TRANS/WP.29/GRE/2004/28  
19 July 2004

**PROPOSAL FOR DRAFT AMENDMENTS TO REGULATION No. 48**  
**(Installation of lighting and light-signalling devices)**

Transmitted by the Informal Group "Adaptive Front-lighting Systems (AFS)"

Apparent surfaces of lighting units 1 through 11 of an AFS (example)

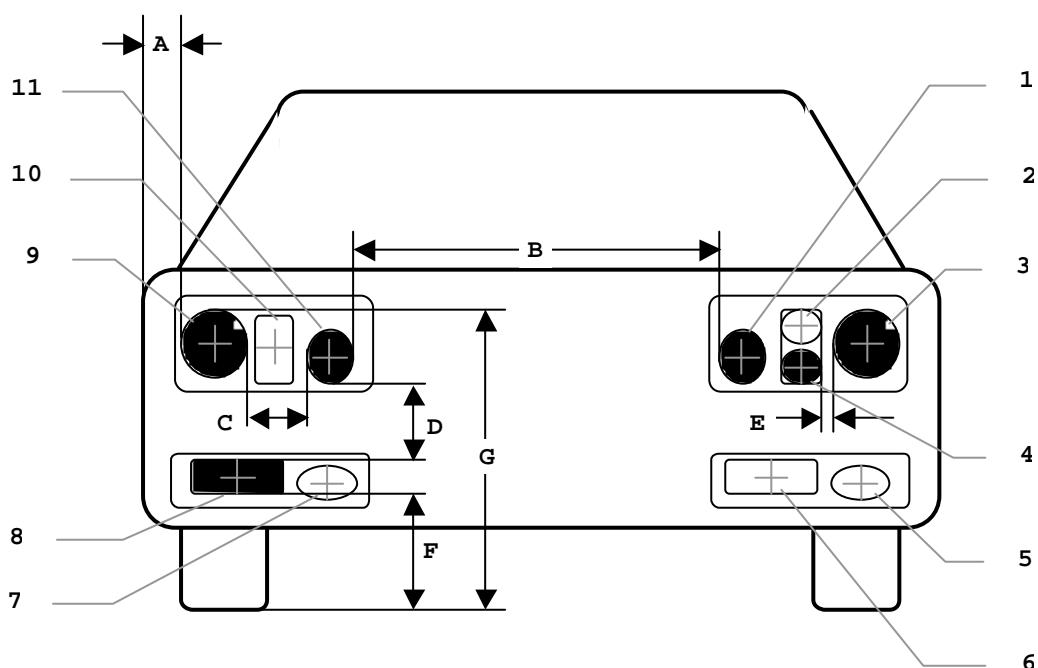
**6.22.4.1.2.** Additional lighting units, if any, on either side of the vehicle shall be positioned at a distance not exceeding 140 mm 7/ in horizontal direction (E in the figure) and 400 mm in vertical direction above or below (D in the figure) from the nearest lighting unit;

**6.22.4.1.3.** None of the additional lighting units described in paragraph 6.22.4.1.2. above shall be positioned lower than 250 mm (F in the figure) nor higher than 1200 mm (G in the figure) above the ground;

for each mode of the passing beam lighting:  
the outer edge of the apparent surface of at least one lighting unit on each side of the vehicle shall not be more than 400 mm from the extreme outer edge of the vehicle (A in the figure); and,  
the inner edges of the apparent surfaces in the direction of the reference axes shall be not less than 600 mm apart. This does not apply, however, for M<sub>1</sub> and N<sub>1</sub> category vehicles; for all other categories of motor vehicles this distance may be reduced to 400 mm where the overall width of the vehicle is less than 1300 mm."
